Safety Recall

N232420460 B-Pillar Trim May Interfere with Roof Rail Airbag Deployment

Release Date: October 2023

Revision: 01

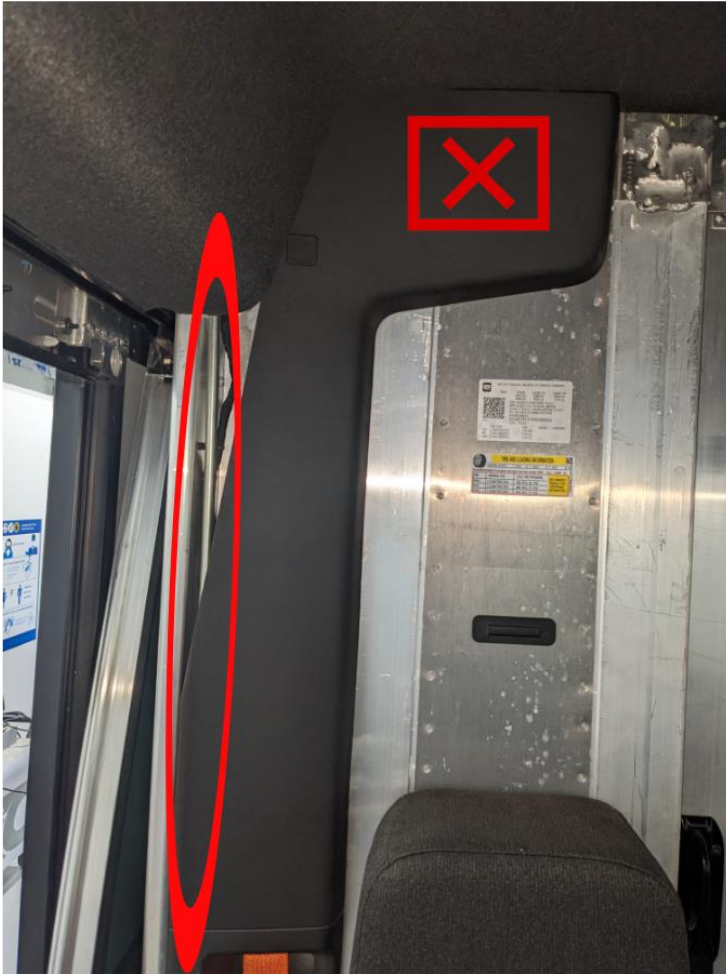
Condition	General Motors has decided that a defect which relates to motor vehicle safety exists in certain 2023 - 2024 model year BrightDrop Zevo 600 vehicles equipped with an optional passenger jump seat. These vehicles may have been assembled with an incorrect passenger-side upper B-pillar trim panel. An incorrect panel could interfere with proper deployment of the right-side roof-rail airbag ("RRAB") in certain side-impact crashes. In certain side impact crashes in which the RRAB deploys, there is increased risk of injury to an occupant in the passenger seat.
Correction	Dealers will inspect the right side B-pillar trim and replace if necessary.

1. Inspect the B pillar trim panel on the passenger's side to determine if it is the correct variant per the above pictures.
 - If the B pillar trim panel is diagonally trimmed in the top left corner AND the airbag rail is visible all the way down to the bottom of the seatbelt bezel portion of the trim panel, no further action is required.

- i. The B pillar trim panel is diagonally trimmed in the upper left portion, but the airbag rail is NOT visible all the way down to the bottom of the seatbelt bezel portion of the panel.

- ii. The B pillar trim panel not trimmed at all in the upper left portion, and the airbag rail is not visible at all.
 - iii. The B pillar trim panel is diagonally trimmed and the airbag rail is visible, but only to the TOP of the seatbelt bezel portion of the panel.

- If the B pillar trim panel has any of the following conditions, replace it. Refer to *Center Pillar Upper Trim Panel Replacement - Right Side* in SI.
